SHURE®

October 4, 1999

Re: FCC ID DD4UC2B
Correspondence Reference Number: 9870
731 Confirmation Number: EA94794
Date of Original E-mail: 09/29/1999

FCC ID DD4UC1B
Correspondence Reference Number: 9790
731 Confirmation Number: EA94793
Date of Original E-mail: 9/23/99

UC2B REFERENCE PLOT W/ TONE KEY DISABLED

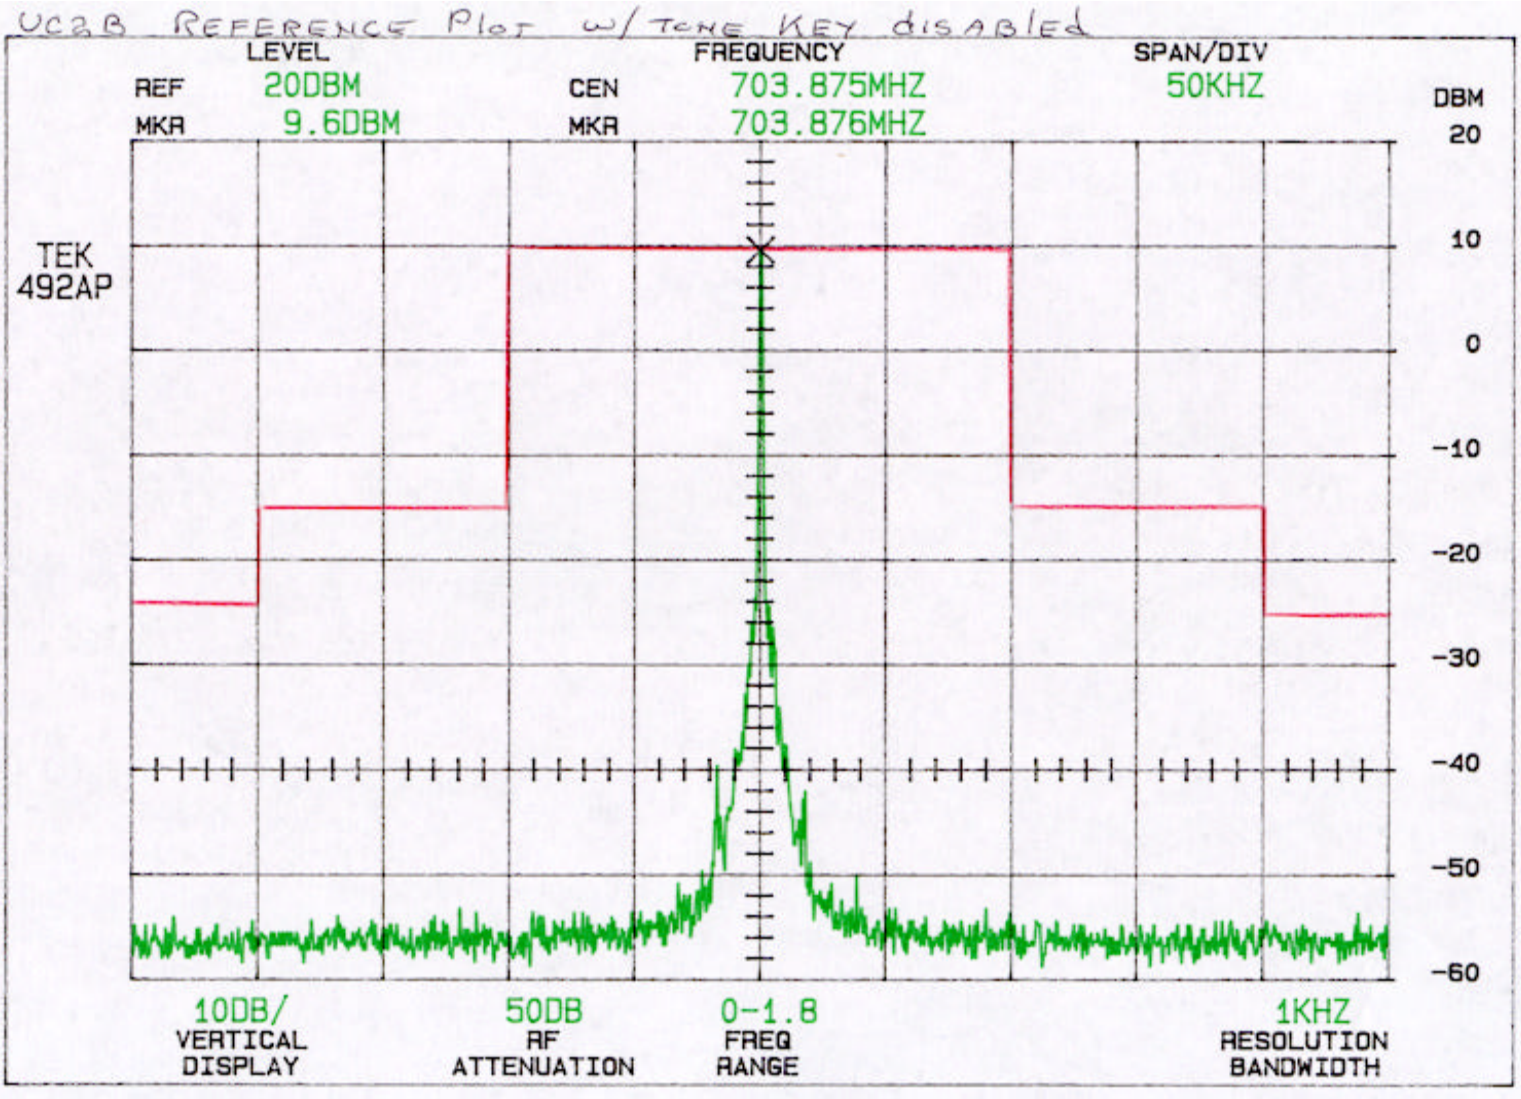
It is possible to perform the procedure in such a way that the modulation due to the pilot signal is ignored in determining the audio input level for 22.5 kHz deviation. To demonstrate this, the above procedure was repeated with the pilot signal temporarily disabled while the audio input level for 22.5 kHz deviation was being determined. A second series of plots showing the resulting emissions have been provided with this attachment. All occupied bandwidth plots were made with the pilot signal re-enabled, with the exception of one reference plot which was made with the pilot signal disabled and no audio input. You will observe that although larger than in the previous set of plots which were included in the original submission, in no case does the occupied bandwidth of the

emission exceed the specified limits. Again, the difference is due to the inclusion or exclusion of the pilot signal in setting up the reference audio input level for 50% modulation (22.5 kHz deviation).

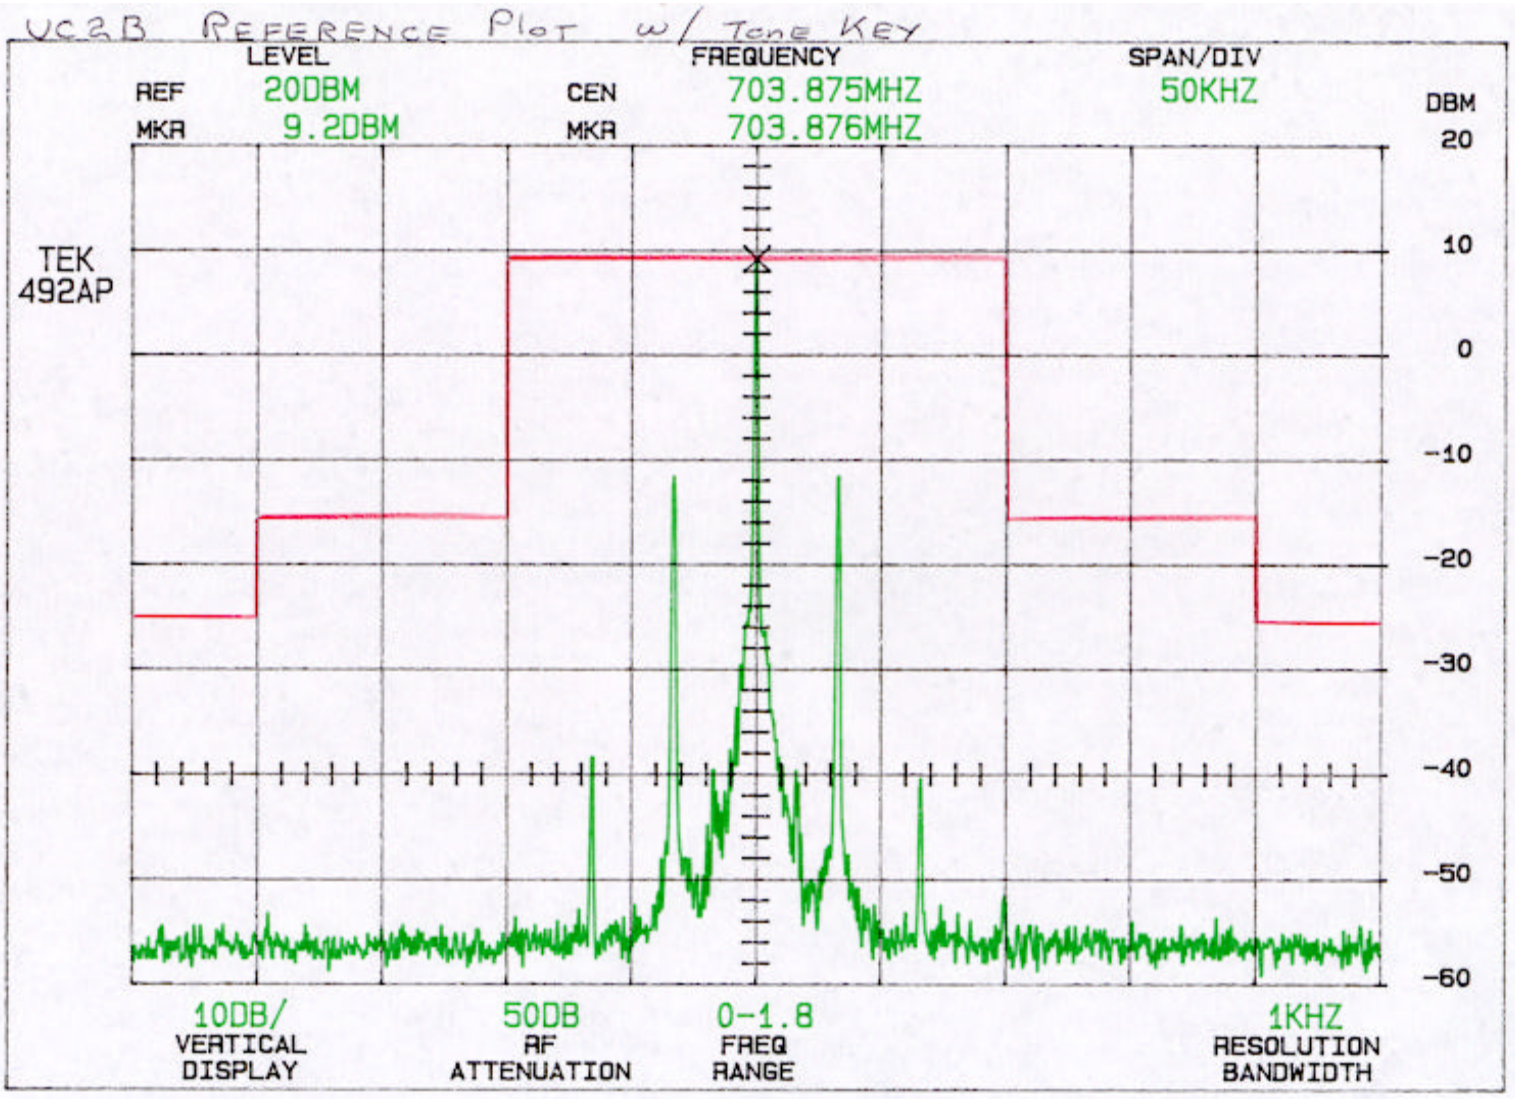
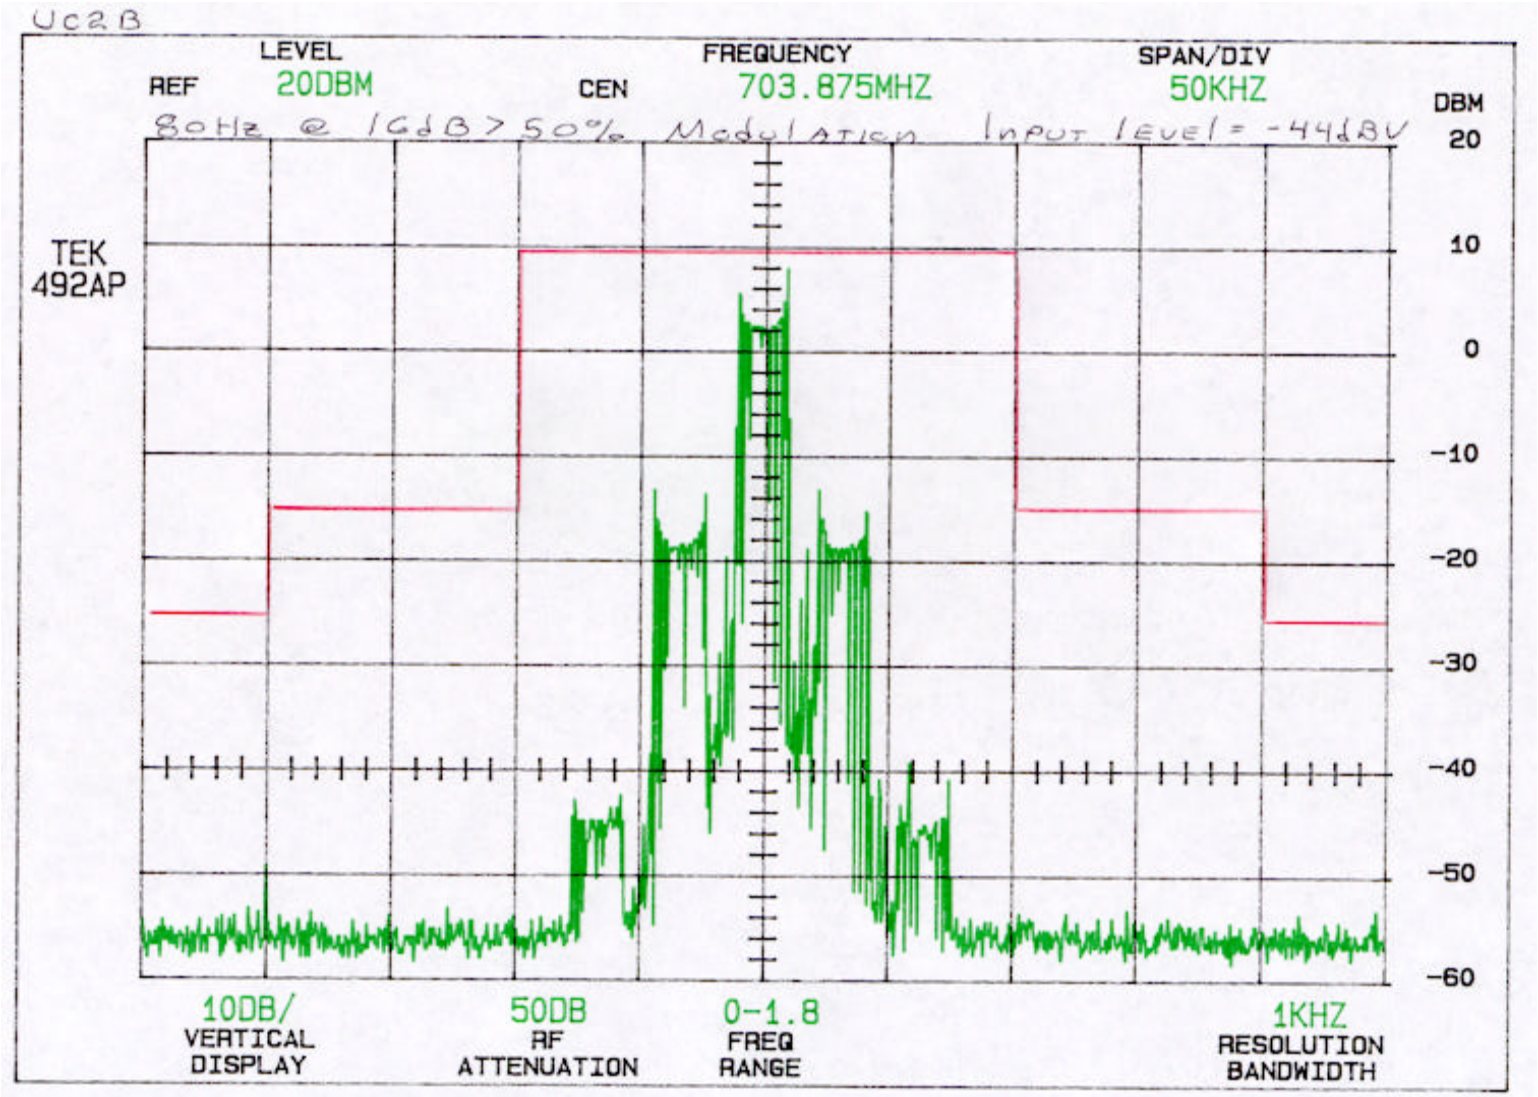
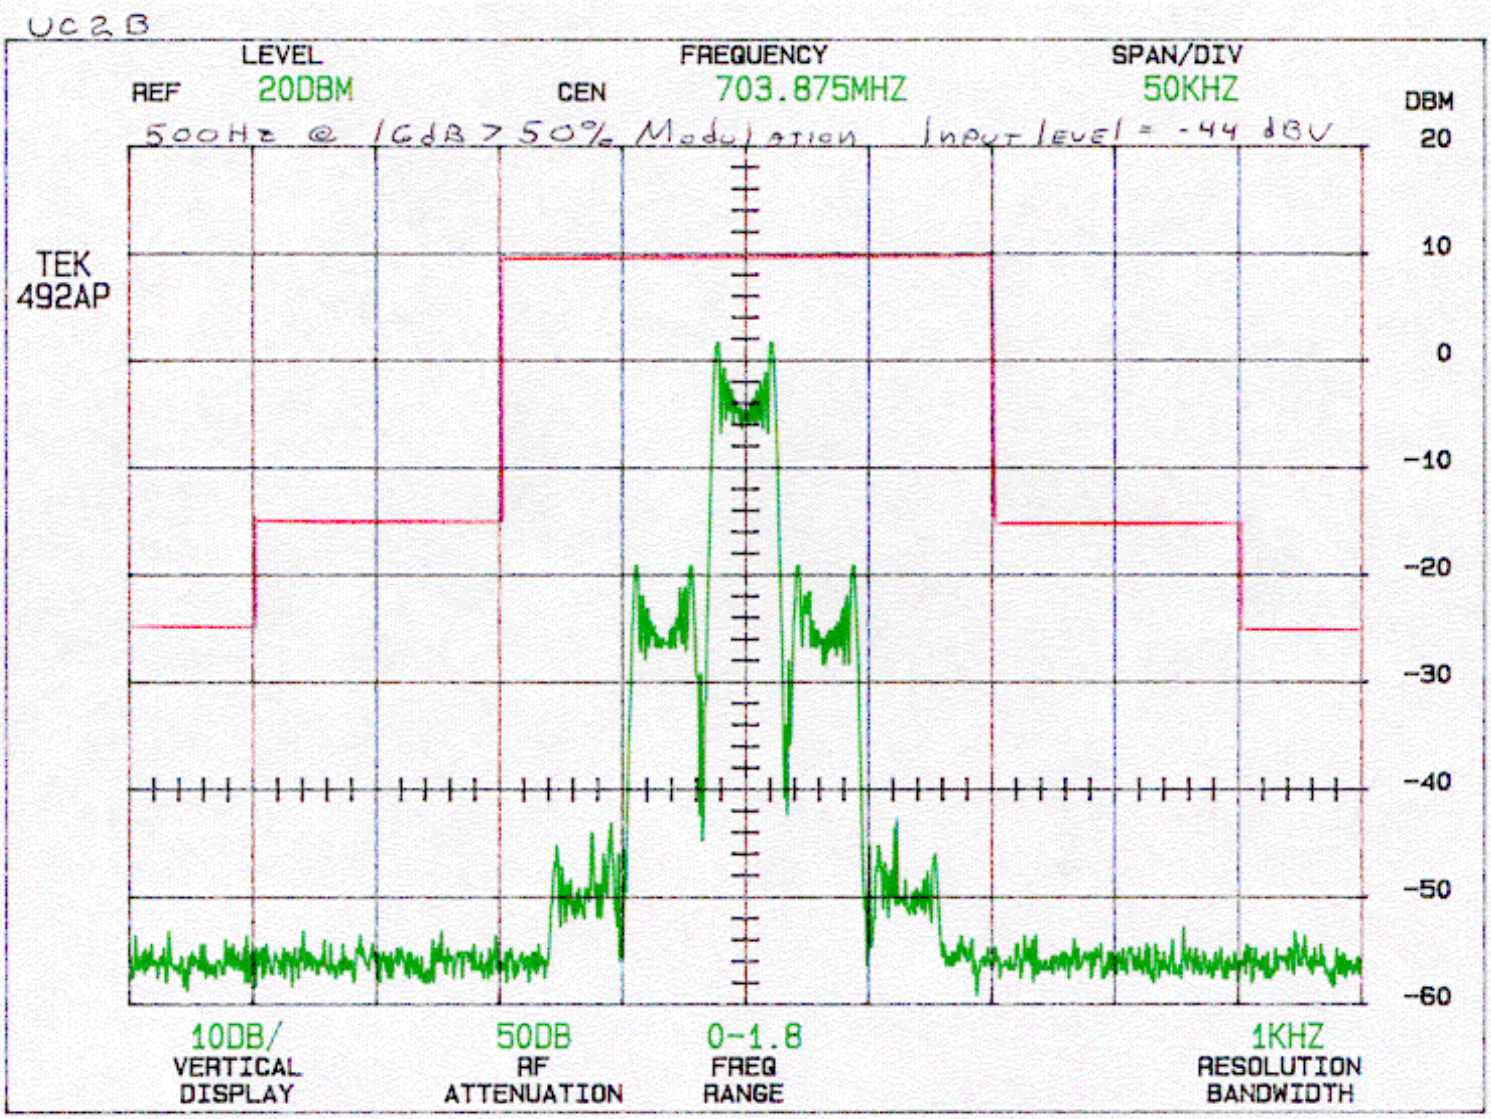
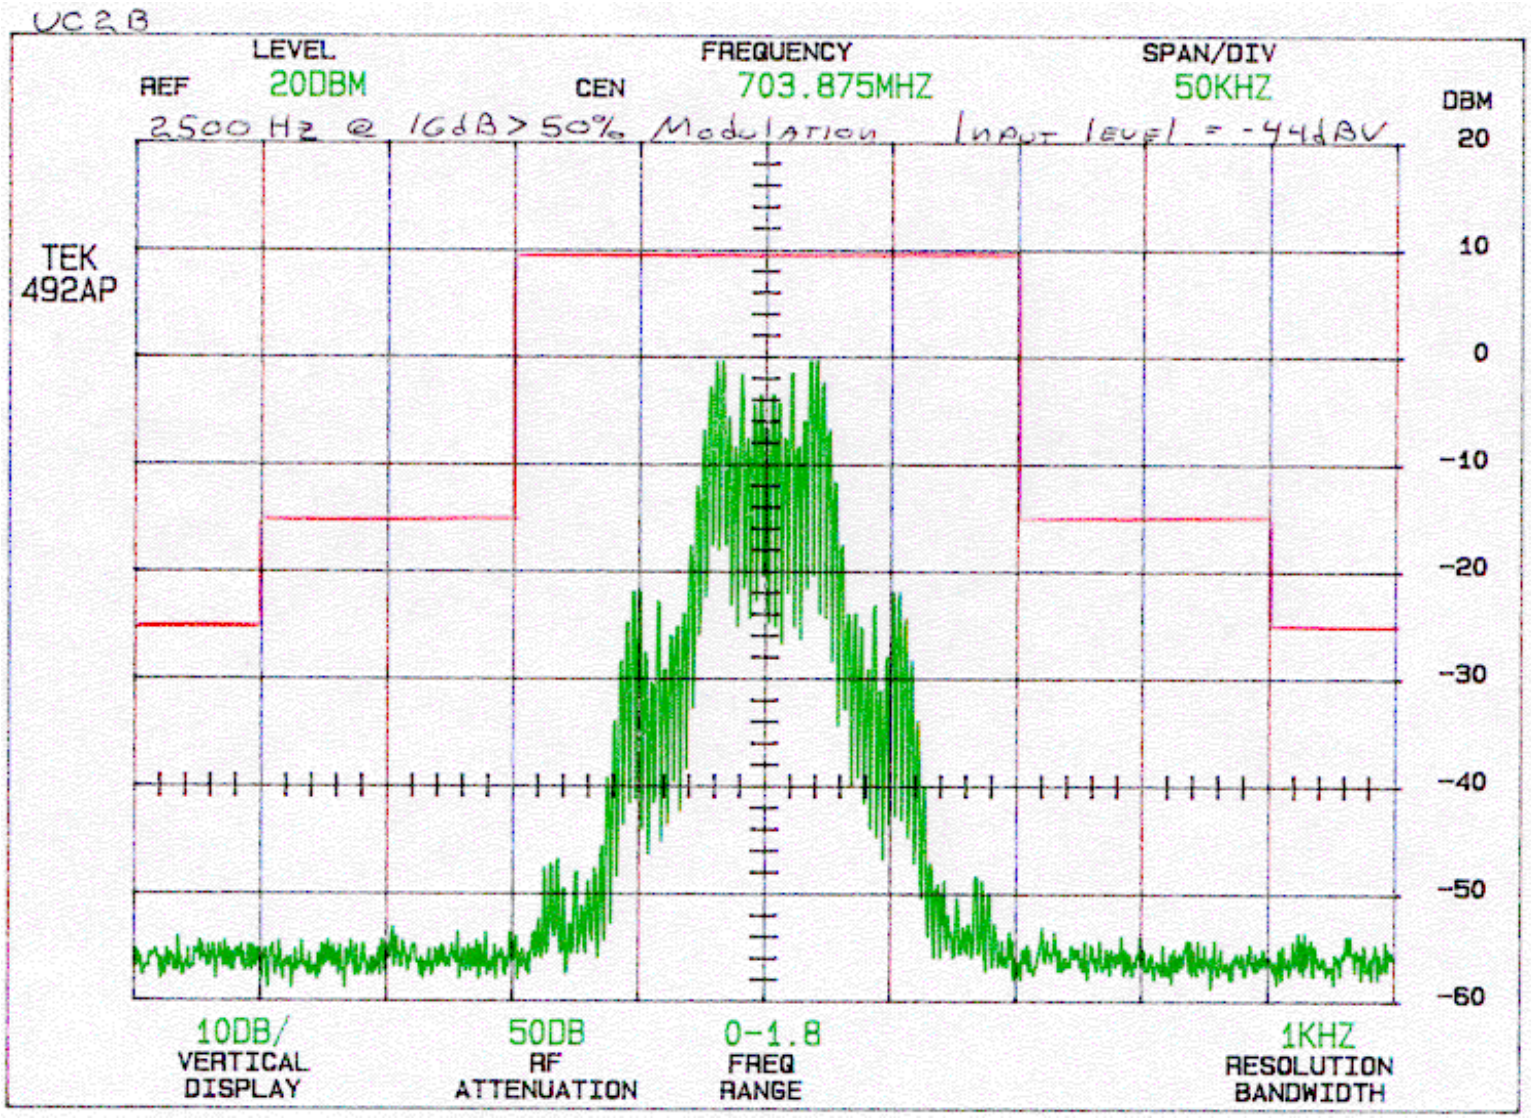
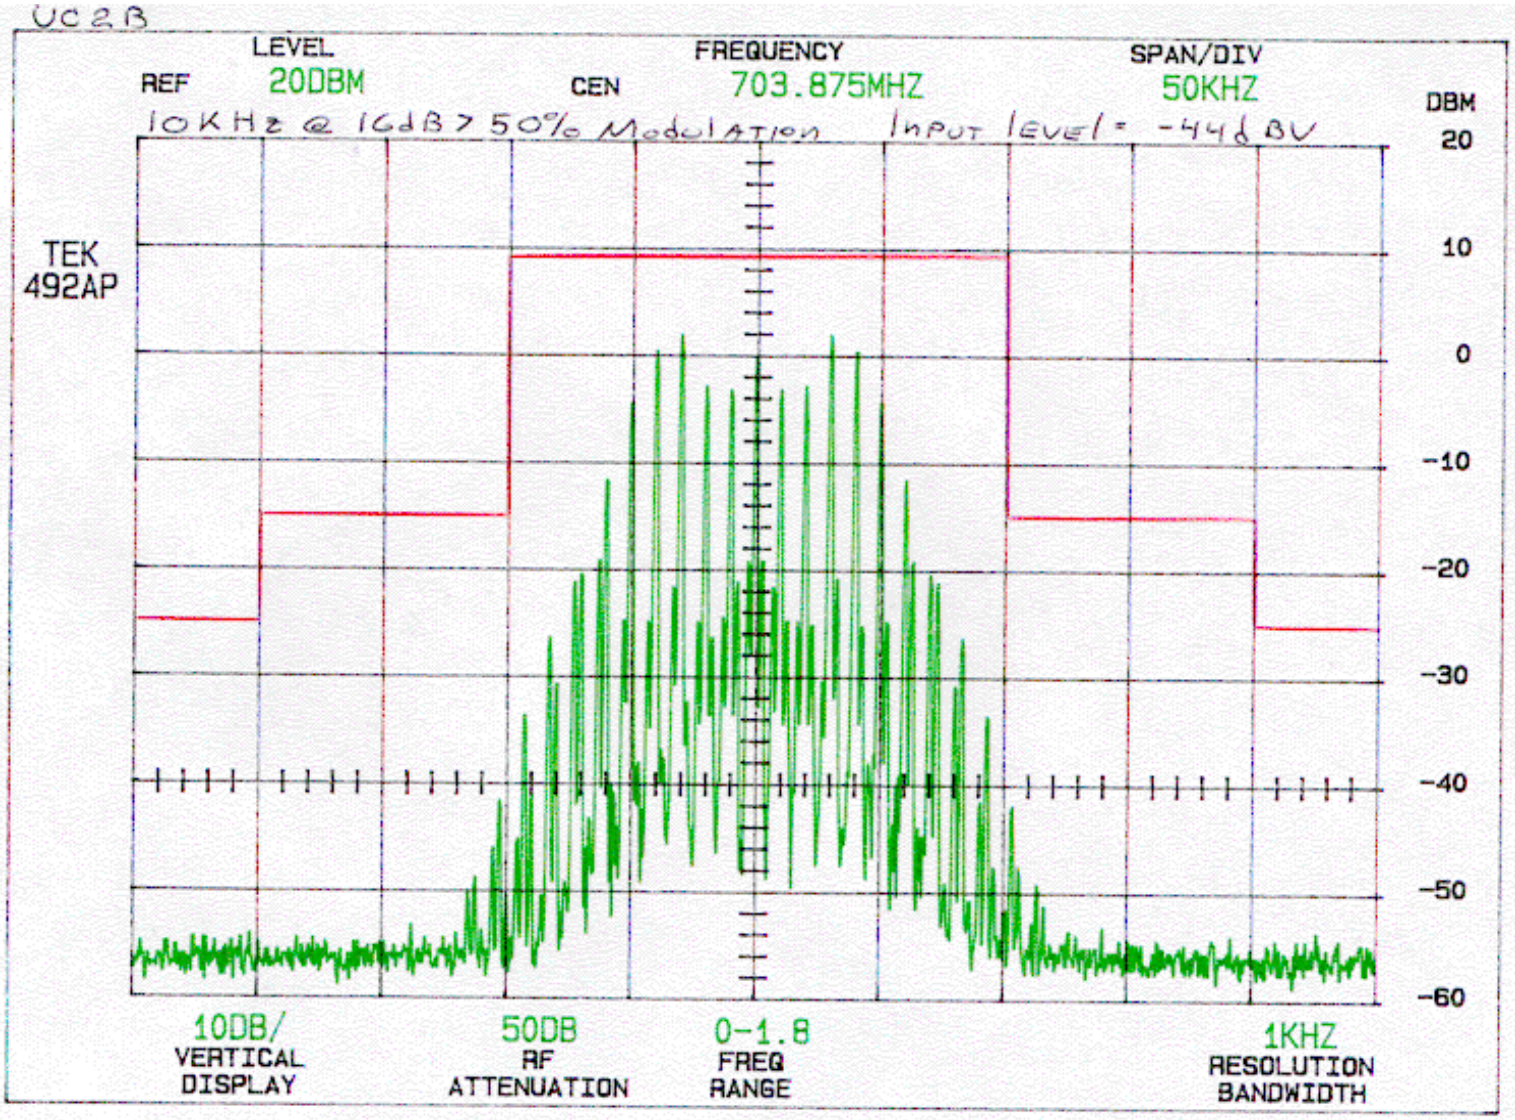
1. The occupied bandwidth plots were obtained by following the procedure detailed below, which was previously recommended by your office:

First, the modulation frequency of maximum response was established by supplying an audio signal to the transmitter input, at a level well below the onset of limiting, and varying its frequency over the entire audio range until the point was found where maximum deviation occurs. Then, the audio signal was adjusted so as to produce 50% modulation (22.5 kHz deviation, in the case of the UC2B) on a Boonton Model 8200 modulation analyzer, and the audio input level was recorded. Next the audio frequency was changed to 2500 Hz, and the input level was increased by 16 dB over that which was recorded at the frequency of maximum response. A plot was then made of the resulting emission. In addition, several other plots were made at other representative modulation frequencies, using the same input level, so as to demonstrate the transmitter's modulation characteristics. A reference plot was also made with no audio modulation applied.

Note that this transmitter incorporates a 32.768 kHz continuous pilot (control) signal (referred to by Shure as "Tone Key"). Note also, that the Boonton modulation analyzer employs a broadband demodulator. Thus, the deviation of the pilot signal affects the setting of the 50% modulation point. This is probably why the modulation plots appear to be undermodulated. A percentage of the deviation is due to the pilot signal.
